Memorandum to ANC 6D re. 1000  $4^{th}$  Street SW (Z.C. Case No. 02-38J) DDOT Scoping Form, dated November 14, 2018

#### **TECHNICAL MEMORANDUM**

Subject: 1000 4th Street SW (ZC Case No. 02-38j)

**ANC Response Memo**

Figure 1: Background Developments Included in the CTR

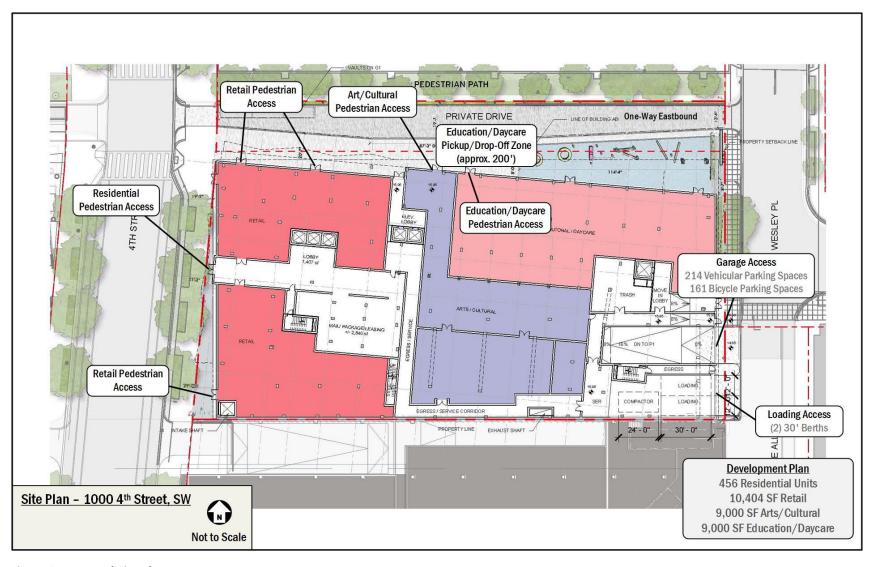
**ANC Comment:** "This CTR proposes a traffic study that only takes current traffic counts and will probably extrapolate using only additional traffic generated from this one parcel. It will not be taking the other projects in the area that will be coming on line either before or close to completion of this project. [Gorove/Slade] needs to add projections from the following PUDs: Waterfront Station parcels at 375 & 425 M Street, Bernstein building on K &  $3^{rd}$  Streets, the upcoming addition by Mill Creek on  $6^{th}$  Street, and the P.N. Hoffman project at M &  $7^{th}$  Street, as well as the second stage of the Wharf Project".

**Response**: The CTR takes into account several background developments, background roadway improvements, and regional background growth, in addition to traffic generated by 1000 4<sup>th</sup> Street. As referenced on Page 6 of the draft CTR scoping form and as shown on the background development map in the scoping attachments (also included as Figure 1 in this document), we are including several background developments as part of the Future Background Conditions and the Total Future Conditions. These background developments include 375 M Street, 425 M Street, the Bernstein Building on K & 3<sup>rd</sup> Street (referred to as Town Center North), the addition by Mill Creek on 6<sup>th</sup> Street (referred to as The View at Waterfront), and the PN Hoffman project on 7<sup>th</sup> Street (referred to as 680 Eye Street SW), amongst other developments. Per DDOT and ANC comments, we will also be including Phase 2 of the Wharf project.
